**Subject: TP2000 Retail I/O Board (90000161) and TeamCOMBO Board (90000273)**

"On" is in the up position  
SW4 & SW3 pictured above on the Retail I/O Board

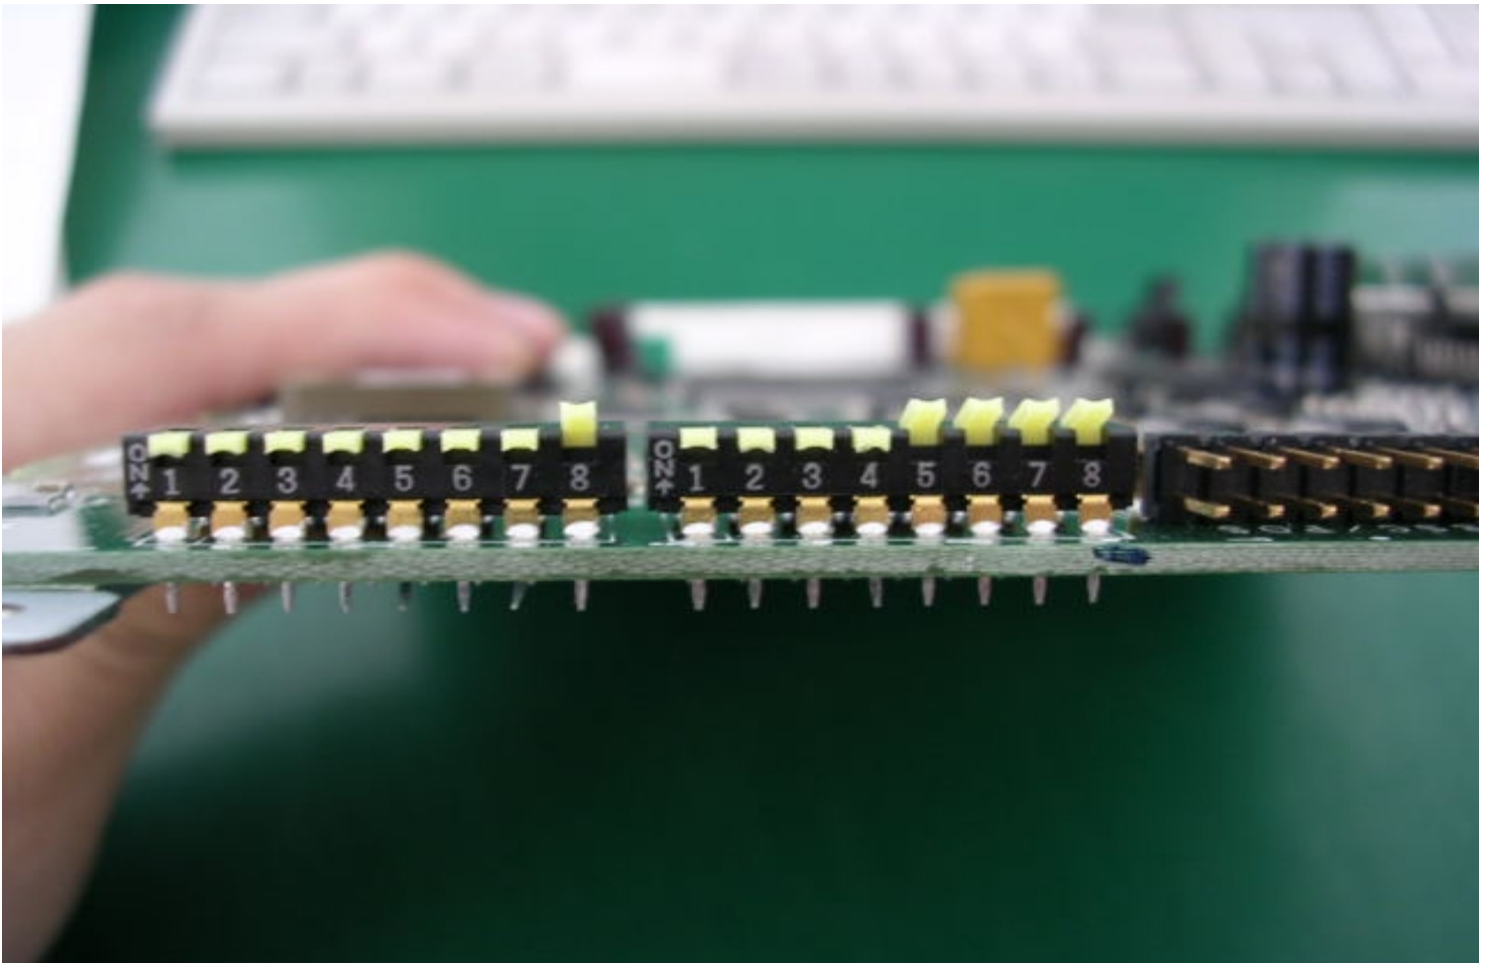
There is a possibility of inaccurately setting switch packs (SW3 & SW4) on the Retail I/O board and switch pack #3 (SW3) on the TeamCOMBO board. The TeamCOMBO board (90000273) only has one switch pack (SW3); while the Retail I/O board pictured below has two switch packs. There are two different types of switch packs approved for the TeamCOMBO board. One switch pack is set to "ON" when the switch is in the up position, and another has the switches set to "ON" when the switch is in the down position. In order to accurately determine how to set these switches, a visual inspection of the switch pack is necessary. In the picture directly below the arrow is pointing upward just below the word "ON". This is the most common switch pack on the Retail I/O board and indicates that the switch is in the "ON" position when up (away from the board).

Please verify the switch pack settings by visually inspecting the arrow position on the board after replacing a Retail I/O or TeamCOMBO board. Simply setting the switches the same as the previous board without verifying which position is "ON" could result in a board that doesn't function. The table on the following page shows the switch pack options.

"On" is in the down position (Retail I/O board Pictured)

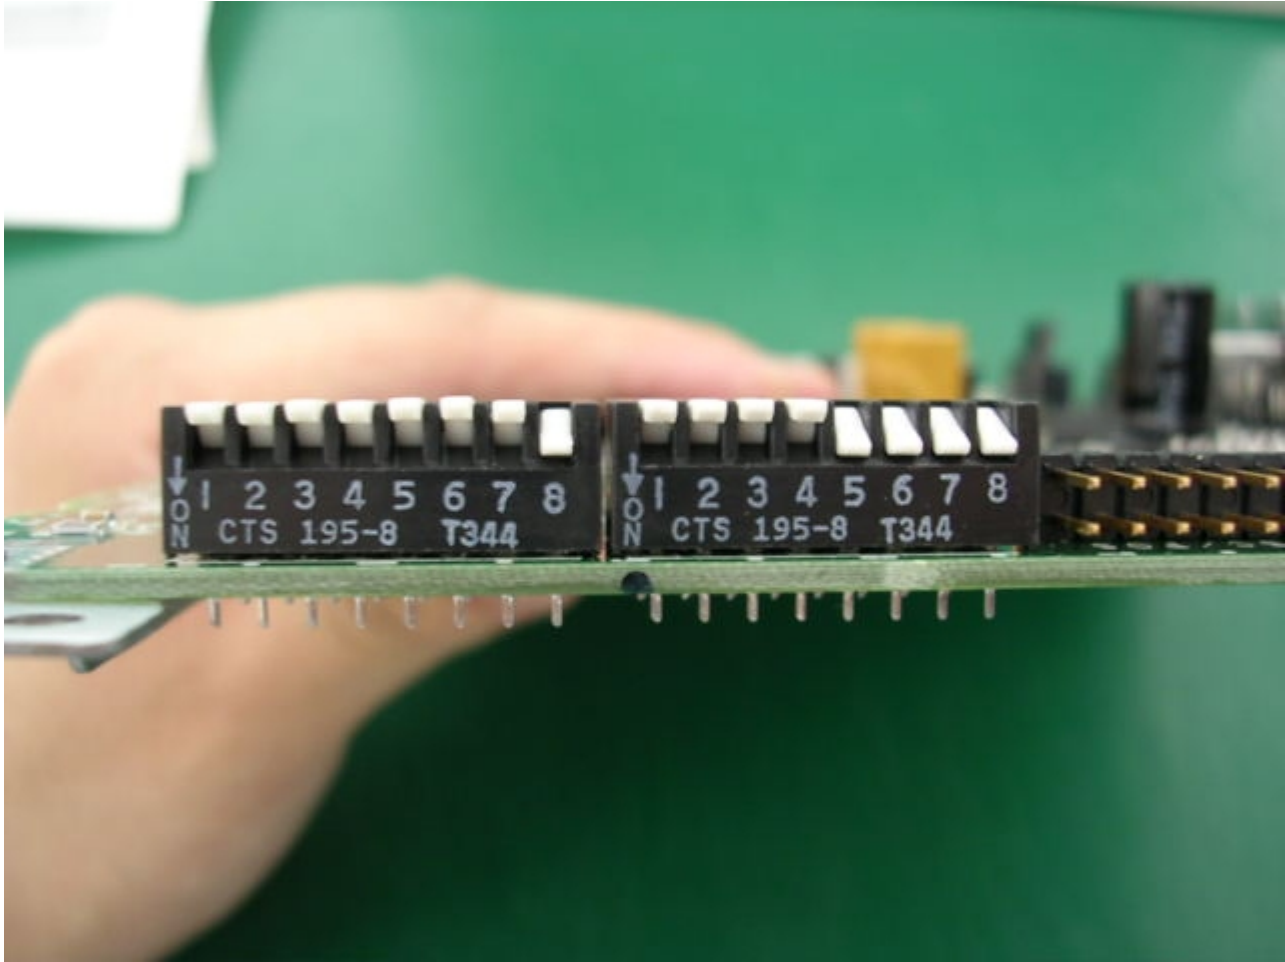
The picture directly above shows the arrow pointing downward for the "ON" position. Both switch packs have been approved on the TeamCOMBO board, but only some Retail I/O board will have the above switch pack installed.
